Access Compliance Report

Public Rights-of-Way

(Curb Ramps)

Intersection ID: 50100	Main Street: PECAN_FLATS_DR	Cross Street: SUNRISE_VIEW_DR	Location: W
ADA ID: FE6DE43361CD	Ramp Type: BlendTrans1	Initial Pass/Fail: Fail	Overall Compliance: No
Severity Score: 8.75			
Codes/Mitigation Info/Possible Solution		Field Measurements/Component Compliance

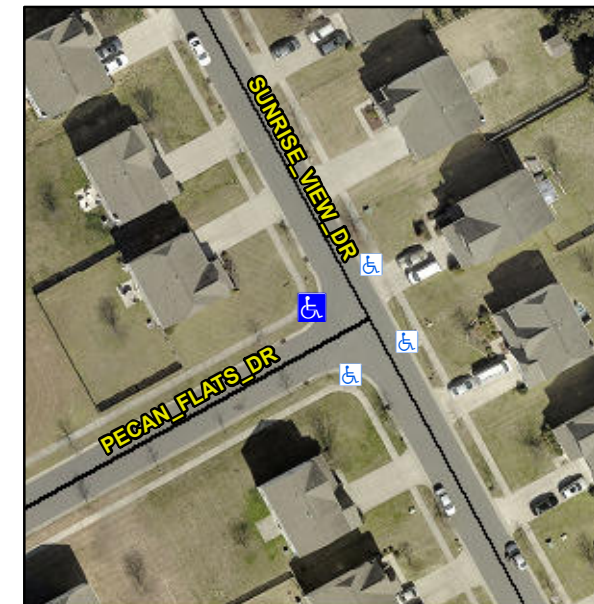
Not Found, R304.5.1

Remove & Replace Curb Ramp With Two New Directional Ramps or Equivalent.
